Subject: AP1000 Response to Request for Additional Information (SRP 9)

RAI-SRP9.1.4-SBPB-01 R2
RAI-SRP9.2.2-SBPA-02 R1
RAI-SRP9.2.2-SBPA-13

AP1000 TECHNICAL REPORT REVIEW

RAI Response Number: RAI-SRP9.1.4-SBPB-01

Figure 9.2.7-1 (Sheet 4 of 4)

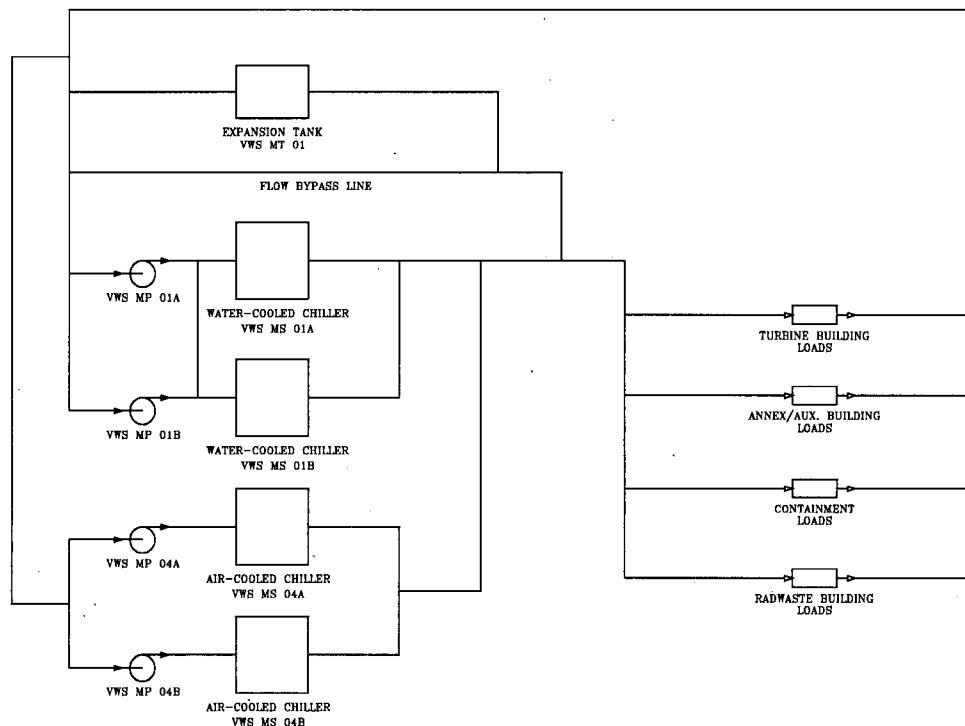
The description that is provided in the AP1000 DCD, Section 9.2.7, does not describe the defense-in-depth and investment protection functions of the CCWS very well. However, it is clear from the ITAAC specified in Tier 1 of the DCD, Section 2.7.2, "Central Chilled Water System," the initial test program described in Tier 2 of the DCD, Section 14.2.9.2.9, "Central Chilled Water System Testing," and Table 17.4-1, "Risk-Significant SSCs Within the Scope of D-RAP," that the CCWS is important for both defense-in-depth and investment protection considerations. It is not clear why this information is not better reflected in the description that is provided for the CCWS in Tier 2 of the DCD, Section 9.2.7, and why no investment protection short-term availability controls (IPSAC) were established for this system. Additional information is needed in the AP1000 DCD to better explain the defense-in-depth and investment protection functions of the CCWS, as well as to explain why IPSAC was not warranted for this system recognizing that CCWS is relied upon to support other defense-in-depth non-safety systems that are subject to IPSAC.

Modify Figure 9.2.7-1: Add Sheet 4 of 4 as shown:

High Capacity
Subsystem Simplified
Sketch
(REF) VWS 004
